From: Joey Howard <joey@cascadestreamsolutions.com>
Sent: Thursday, April 21, 2016 5:23 PM
To: Will Harling
Cc: Petruzzelli, Kenneth@Waterboards; Barbara Brenner; Murano, Taro@Waterboards; Henriouille, Diana@Waterboards; Anderson, Skyler@Waterboards; Feiler, Stormer@Waterboards; Margaret Tauzer - NOAA Federal; Kerry Fuller; Rocco Fiori; Bean, Caitlin@Wildlife; Elfgen, Mark@Wildlife
Subject: Re: Stanshaw Scope of Work - Questions from Water Rights Division and North Coast Regional Water Quality Board
Attachments: Marble Mountain Pipeline.pdf; HW Pipe Calcs.xlsx

In your letter dated April 15, 2016, you stated that the Coles were meeting with their engineering and implementation teams today to discuss and approve designs for the outfall point. The Division and the Regional Board have a number of questions about the scope of work and, in light of the meeting today, I wanted you to have the questions available. Also, I still believe it would be productive for us to go over these questions in a meeting or conference call. If you are open to meeting, please let me know so we can set up some dates.

Marble Mountain Ranch
 Water Efficiency Study
 Plan View

Marble Mountain Ranch Water Efficiency Study Pipe Profile

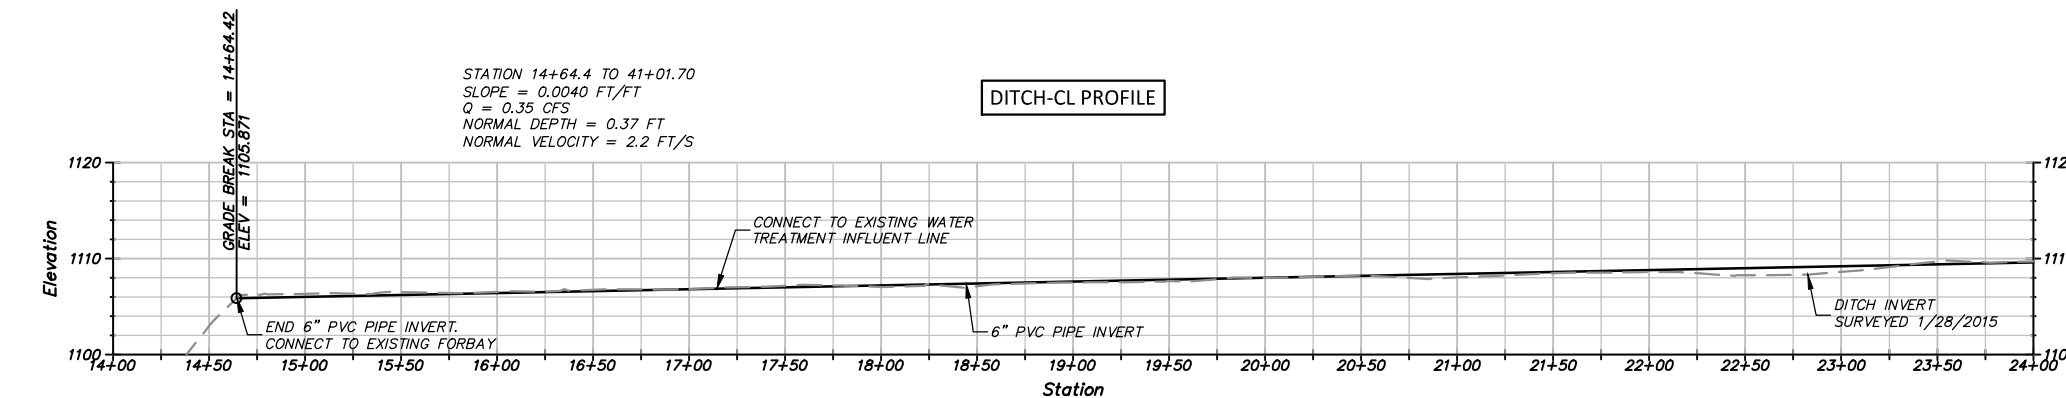
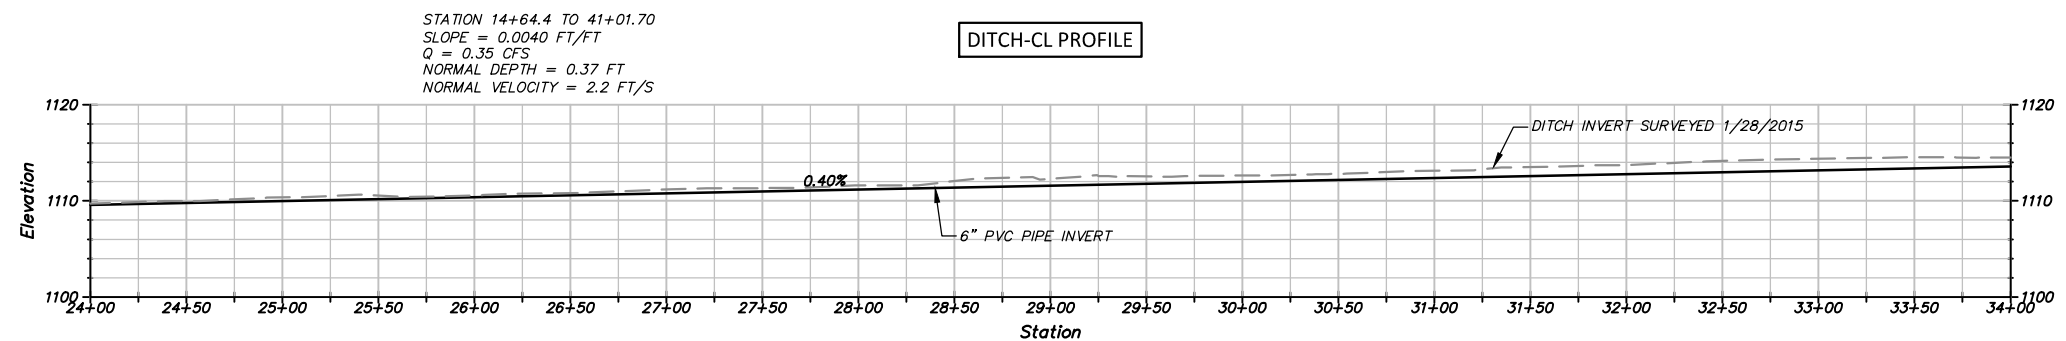
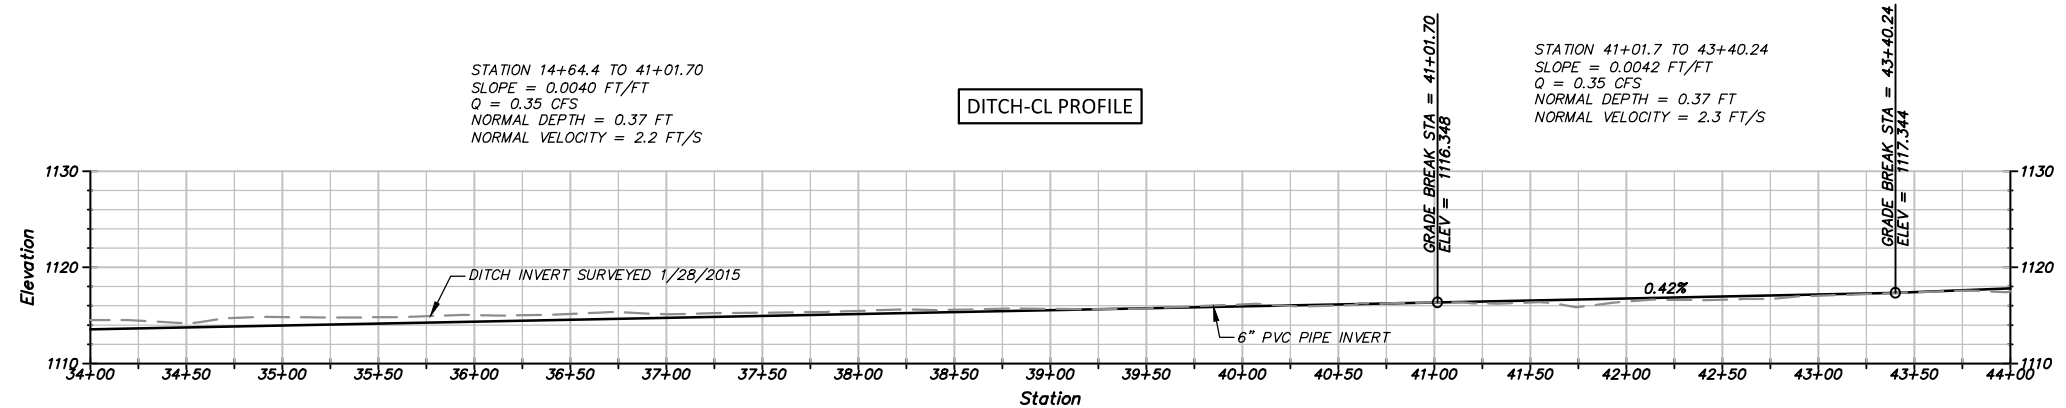
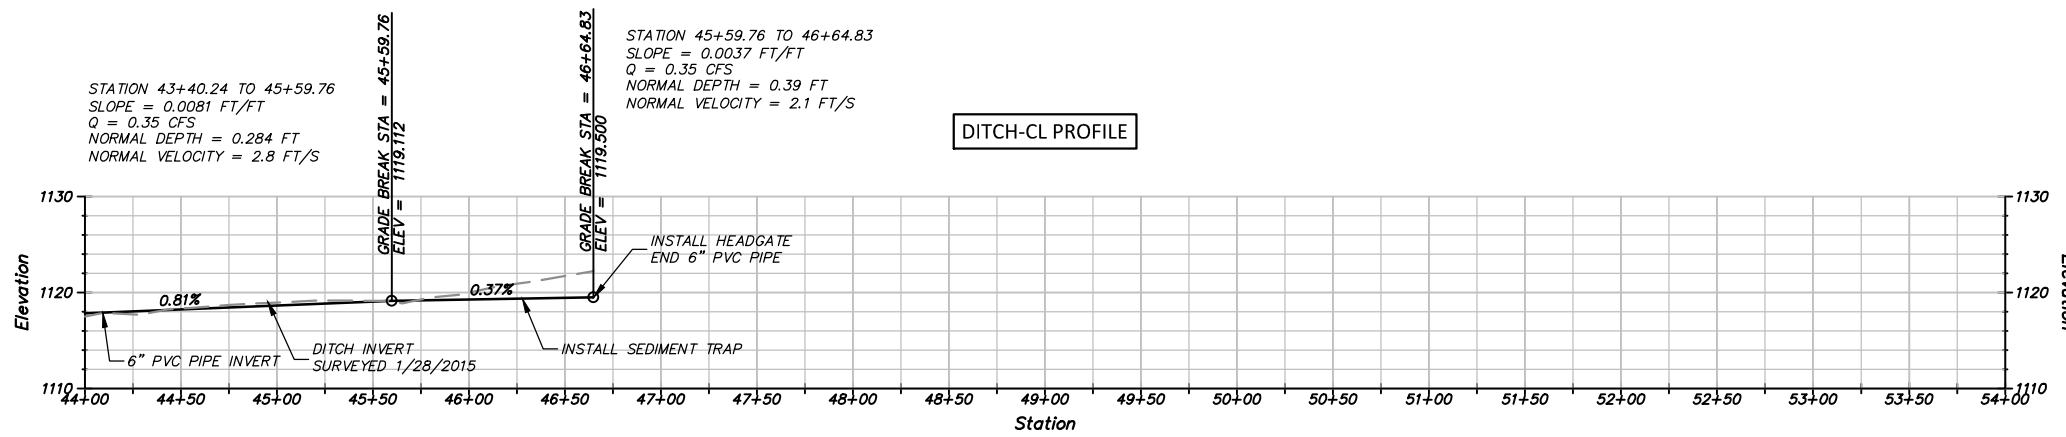
2) The two documents cite different amounts of water that will be diverted via the 6-inch pipes. On page 2 of the PDF titled Marble Mountain Pipeline the Q value = 0.35 CFS. In the document titled "40710 Revised SOW for Additional Funds _Task six Revision" (SOW) in the second paragraph of section Task # 6 it states that the pipeline is sized to convey 0.31 CFS. The two documents are reporting a different volume of water will be diverted in the 6-in pipe.

I mistakenly thought the preliminary pipe alignment plan had made it to Margret. I apologize for not getting it to you. Please note that I based the pipe size on open channel flow within the pipe using Manning's equation and ignoring losses at bends. I also calculated the flow in the pipe assuming full flow and a friction slope equivalent to the ditch slope using Hazen-Williams equation (see attached spreadsheet). I believe it is prudent to use a valve to regulate flow in the pipe (i.e. headgate) and having the pipe a bit larger to accommodate debris that may collect in the pipe.
